New "RK" Flange for 277/278 Series

Chelsea engineering has developed a new Rotatable Cast Iron flange for the 277/278 Series Power Take-Offs (P.T.O.s). This new design is a first for Chelsea and the work truck industry as you now have the option to specify a ROTATABLE WET SPLINE.

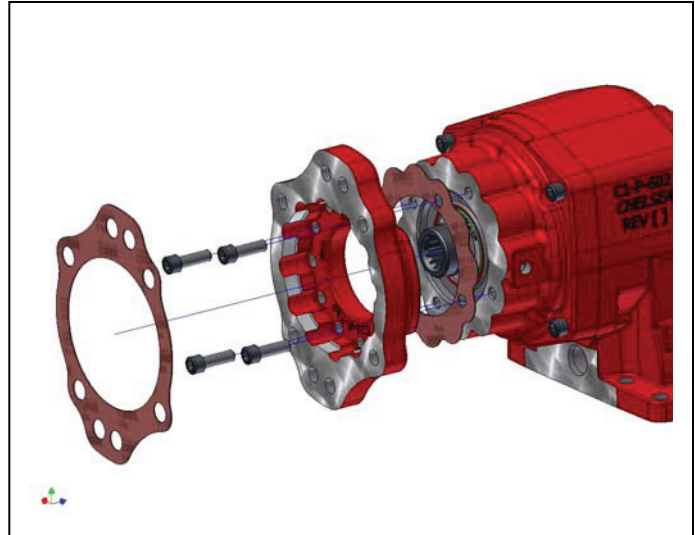
The new "RK" (Patent Pending) S.A.E. "B" 2 or 4 Bolt with a "B" Shaft (7/8" -13 Tooth) will replace the current "RA" and "RB" flange options on the 277/278 Series P.T.O.s.

This one flange option now gives you more flexibility in inventory management by replacing the "RA" (S.A.E. "B" 2-Bolt Flange w/ "B" Shaft 7/8"-13T) and "RB" (S.A.E. "B" 4-Bolt Flange w/ "B" Shaft 7/8"-13T) as a standard rotatable or as a wet spline rotatable option.

To Order the "RK" as a wet spline option insert into the P.T.O. model code the letter "W" (Wet Spline) or "V" (Wet Spline w/ Valve Body Rotated 120°) as the "Lube" option and the letters "RK" for the output option.

To order the "RK" as "Standard" (non-wet spline), the "Lube" option would be "P" or "R" and the letters "RK" for the output option.

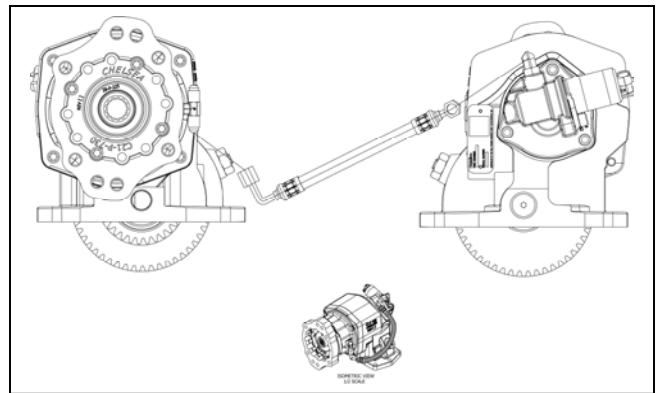
- Wet Spline flange is shipped loose with bolts, gaskets, fitting and hose.
- If ordering a standard “RK” the Flange will be shipped loose with bolts. A gasket is not required between the flange and the P.T.O. bearing cap.
- Standard flange part number:
 - 21-P-759
- Wet Spline flange part number:
 - 21-P-722

- Conversion Kit: “RK” Standard to “RK” Wet Spline
 - 329160-67X

- Refer to Chelsea Owner's Manual HY25-1380-M1/US for torque specifications when installing the rotatable flange to the P.T.O. bearing cap.
